Title-Sujet Jasper Heritage Train Station Roof Rehabilitation Jasper National Park, Parc national Jasper		Date November 21, 2013
Solicitation No. - No. de l'invitation 5P423-14-6523	Amendment No. – No modif. 02	
GETS Reference No. – No de reference de SEAG PW-13-00535965		
Solicitation Closes L'invitation prend fin – at – á 02:00 PM on – le 2013-11-28	Time Zone Fuseau horaire - Mountain Daylight Time (MDT)	
F.O.B. - F.A.B.		
Address Inquiries to: - Adresser toute demande de renseignements à :		
Margot Simpson		
Telephone No. - No de téléphone 780-852-6255	Fax No. – No de FAX: n/a	
Destination of Goods, Services, and Construction: Destinations des biens, services et construction: Jasper National Park, 607 Connaught Drive, Jasper AB T0E 1E0		
Vendor/Firm Name and Address Raison sociale et adresse du fournisseur/de l=entrepreneur		
Name and title of person authorized to sign on behalf of the Vendor/Firm Nom et titre de la personne autorisée a signer au nom du fournisseur/ de l'entrepreneur

Jasper Heritage Train Station Roof Replacement
Solicitation#5P423-14-6523

Answers to comments/ questions put forward at site meeting on November 18, 2013.

FRONT (WEST) ELEVATION

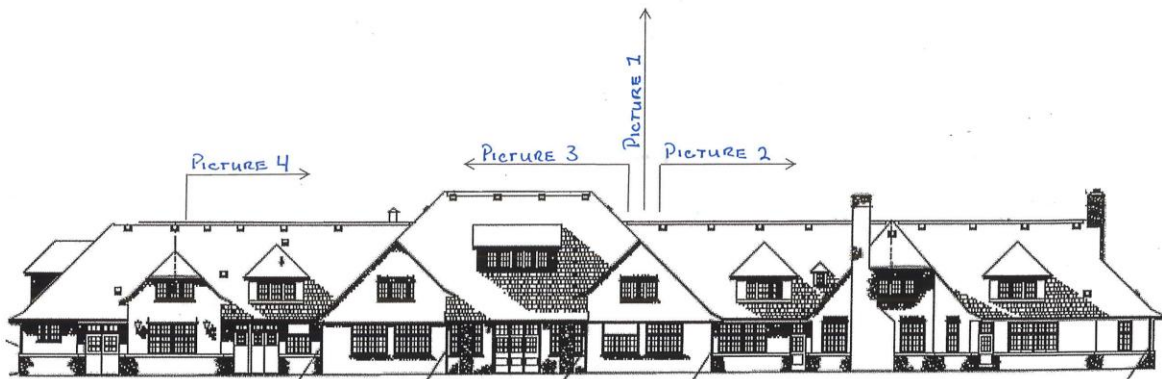
Q4. Is the attic above the vaulted VIA concourse area accessible?

- A. Yes, the attic space above the vaulted VIA concourse accessible. Refer to attached drawing and pictures.
